HILL VALLEY - PHASE 2B

CITY PROJECT NO. 15860
CONTRACT NO. 9680

REVISION 1 - 04/29/26

REVISION 2 - 05/28/26

15860
 U-4

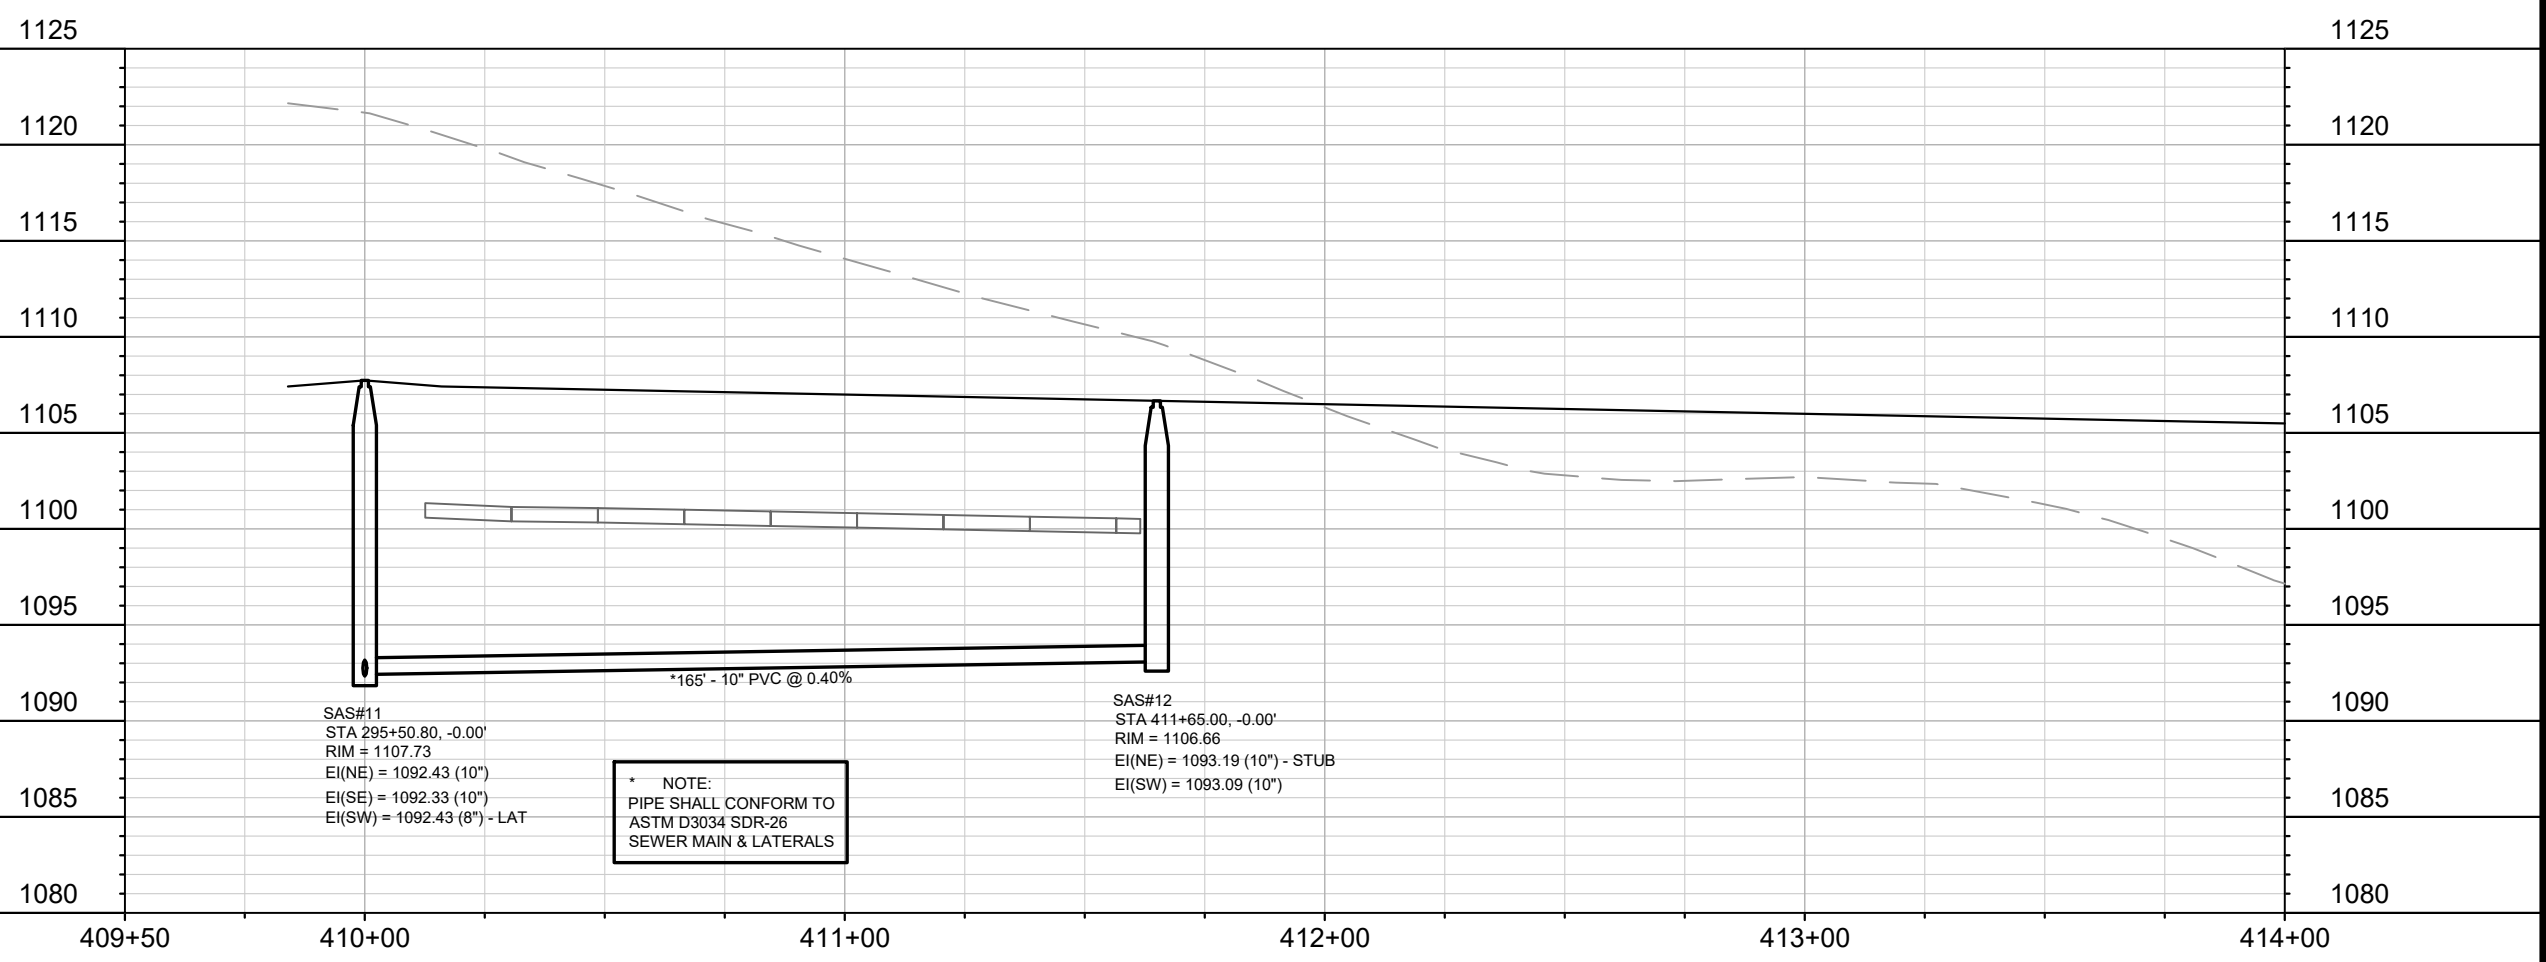
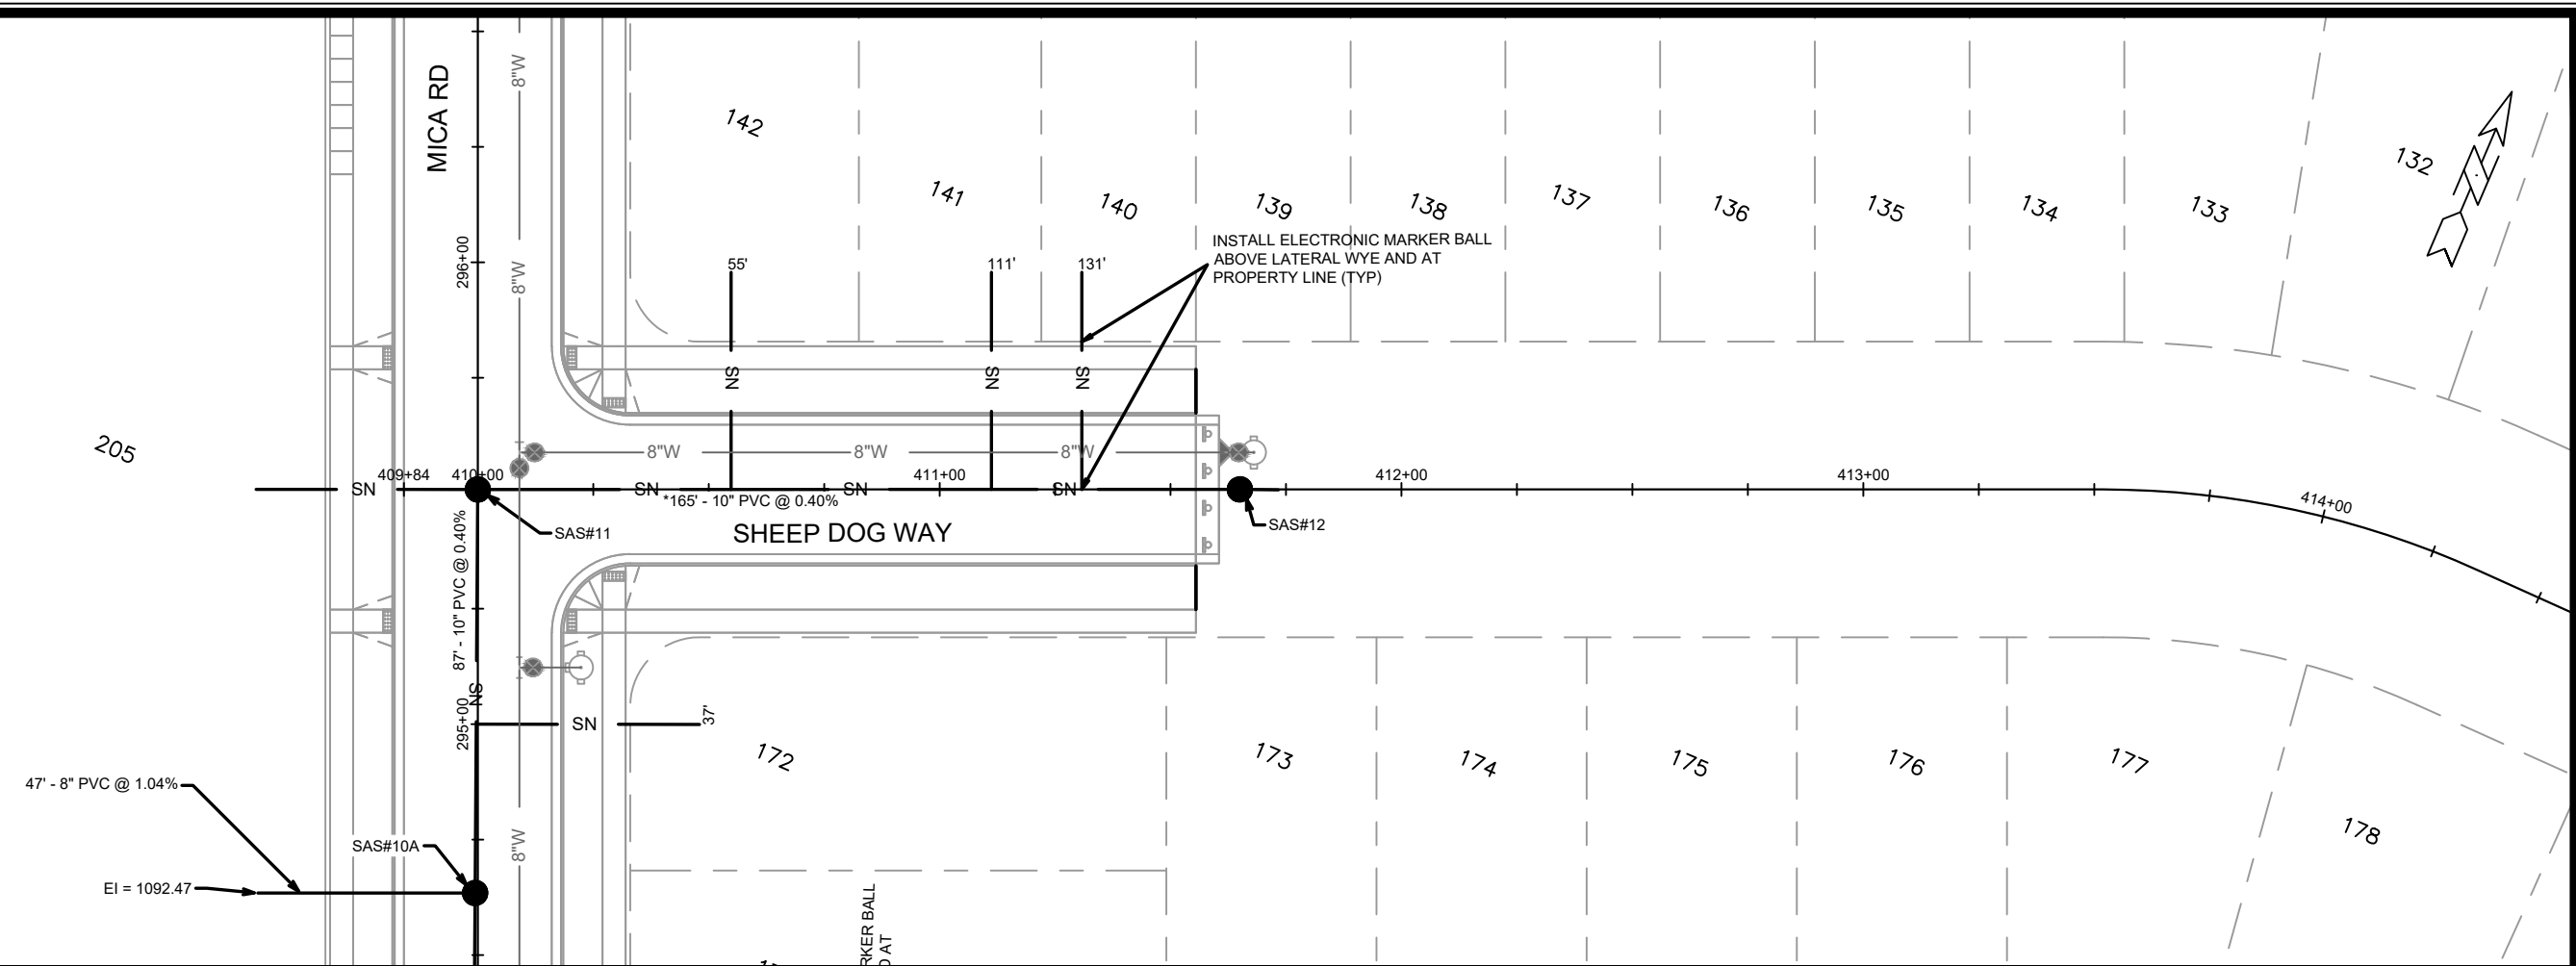
REVISED 5/28/2026 EEA
 -Added pvt storm lateral to Lot 205

UTILITIES PLAN & PROFILE - S PLEASANT VIEW RD - EAST SIDE

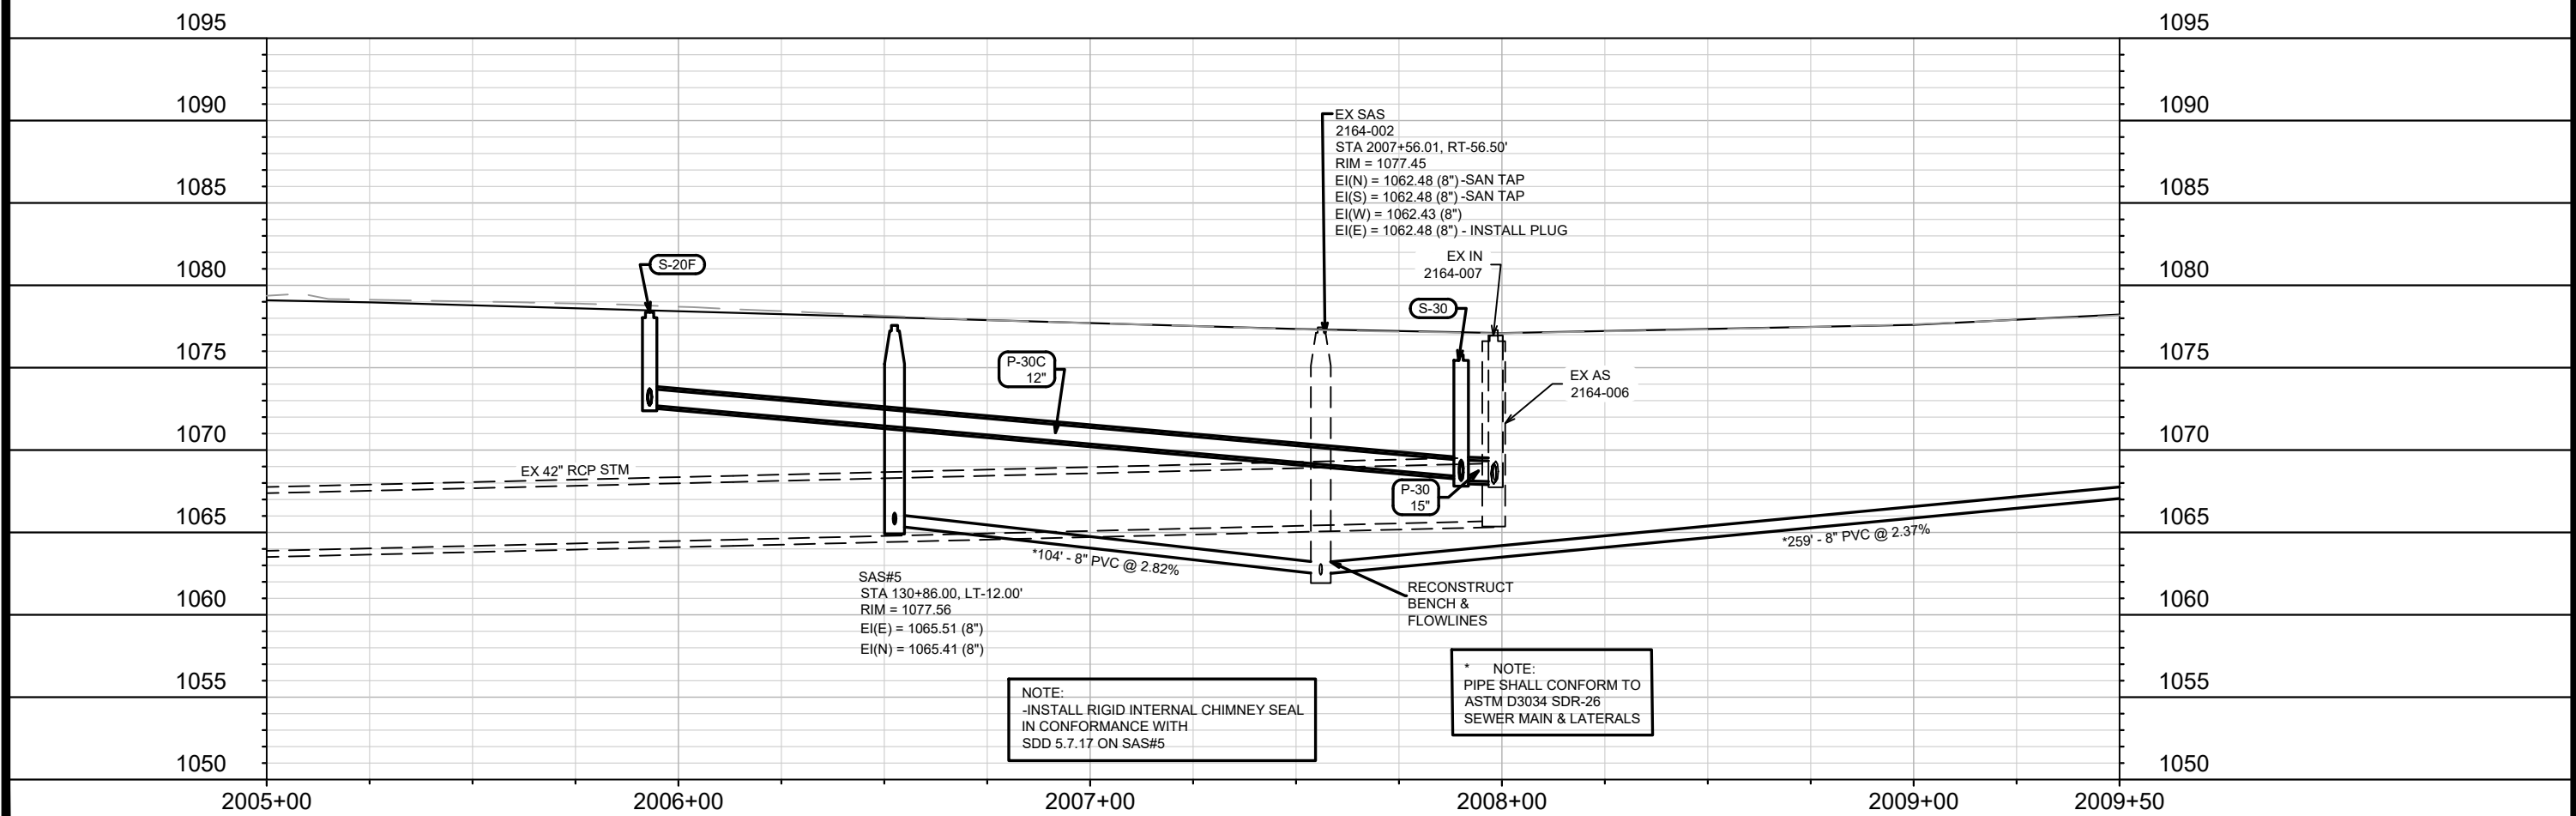
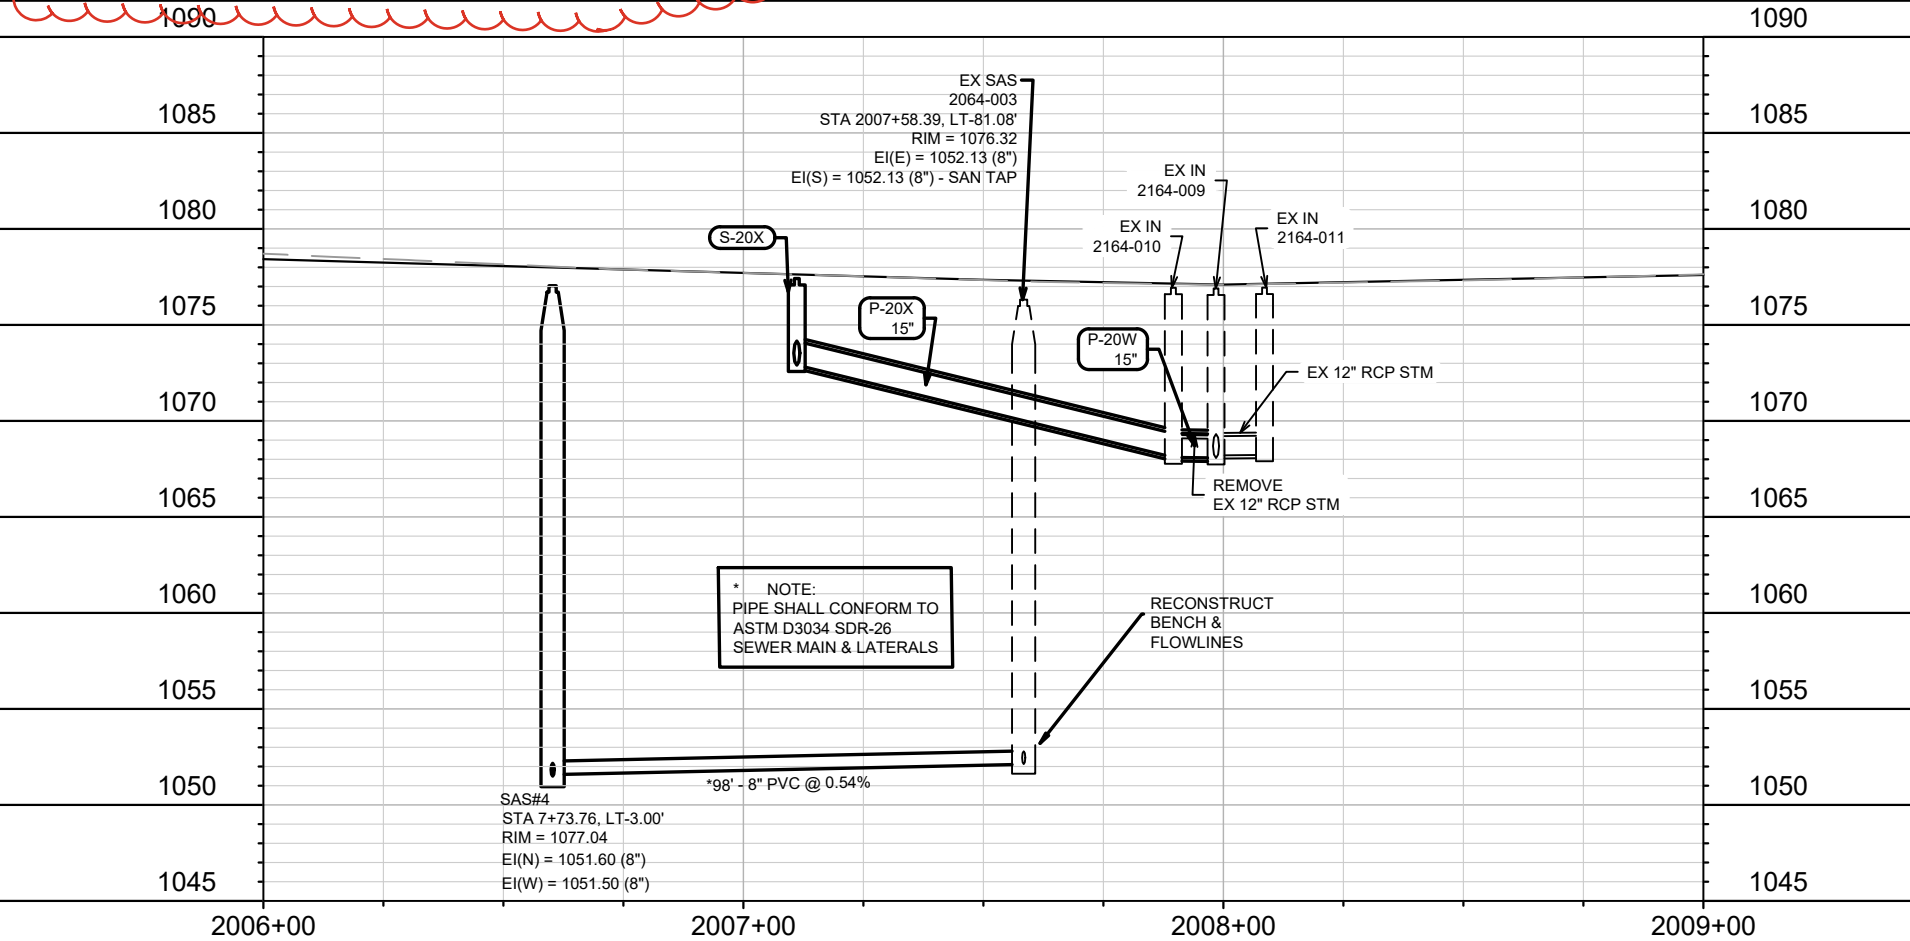
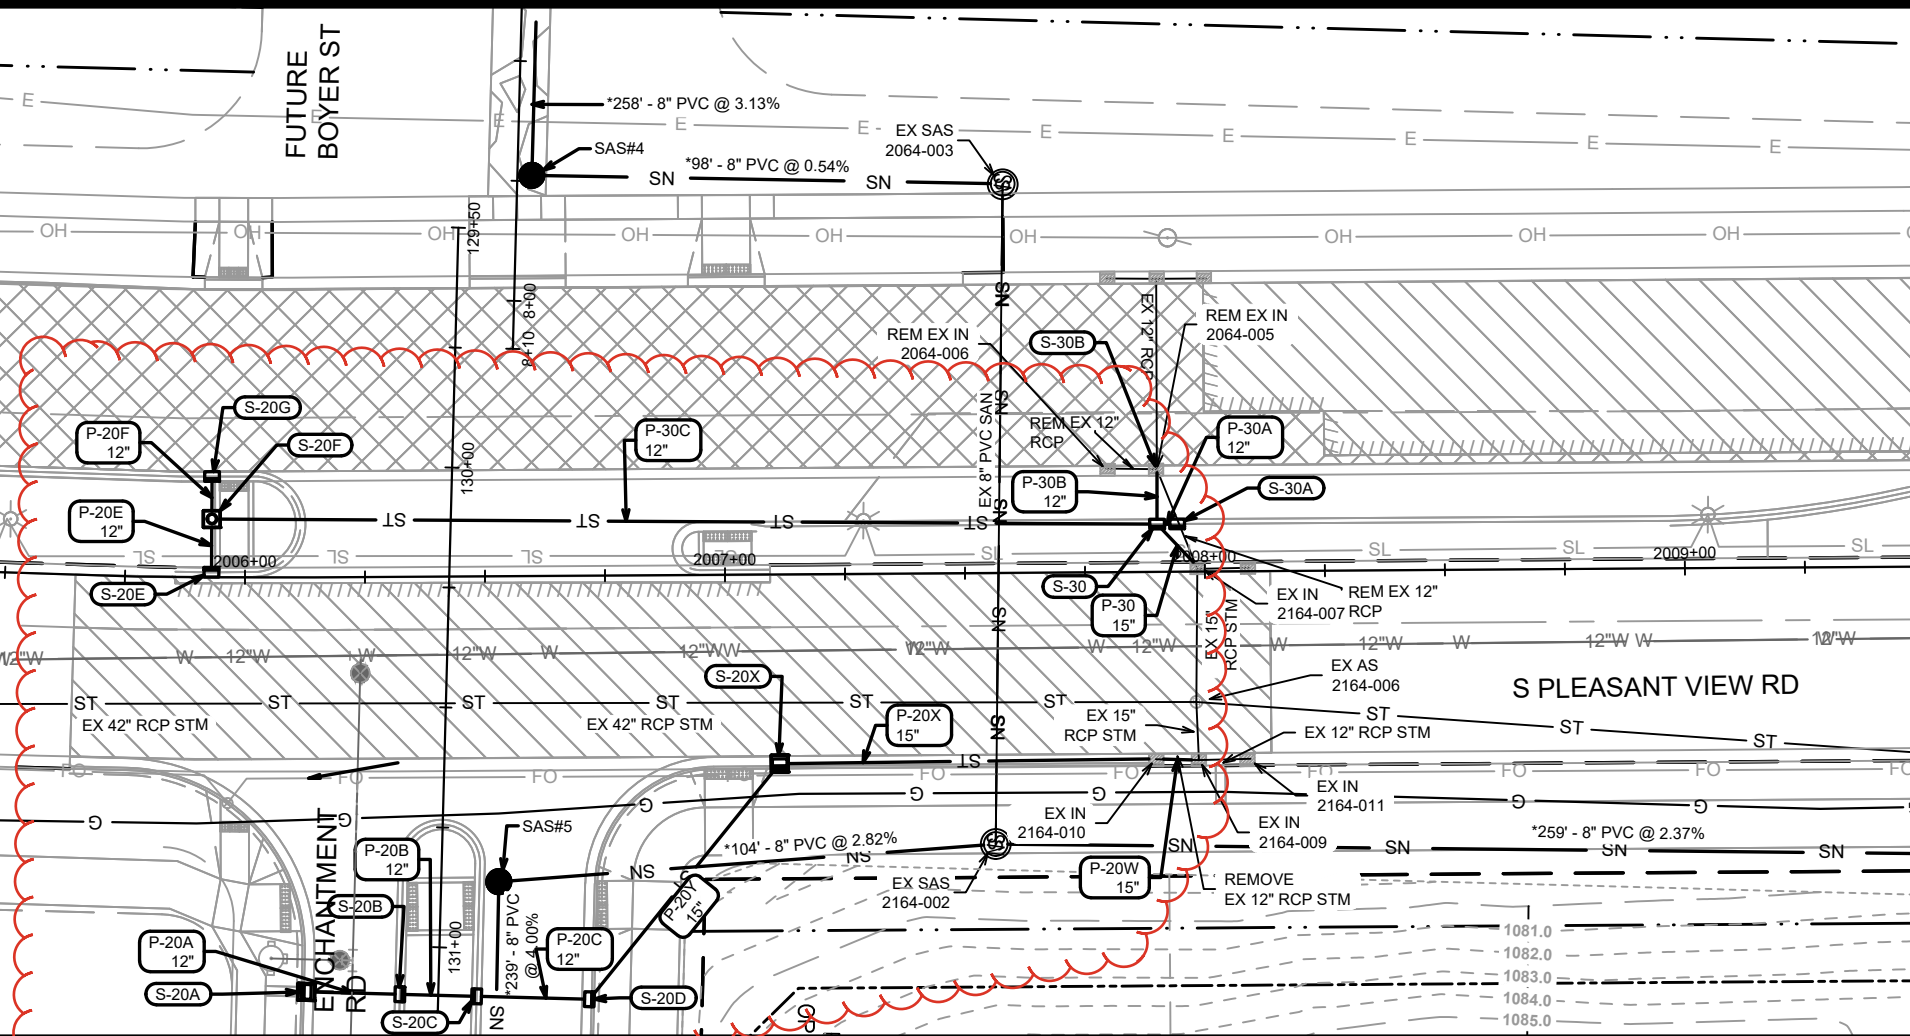
REVISED 5/28/2026 EEA
 -Deleted structure S-20 & pipes P-20 & P-20D
 on Pleasant View Rd.
 -Added pipes P-30C, P-20X, P-20Y & P-20W
 -Added structure S-20X
 -Revised inverts on structures from S-20A to
 S-20D
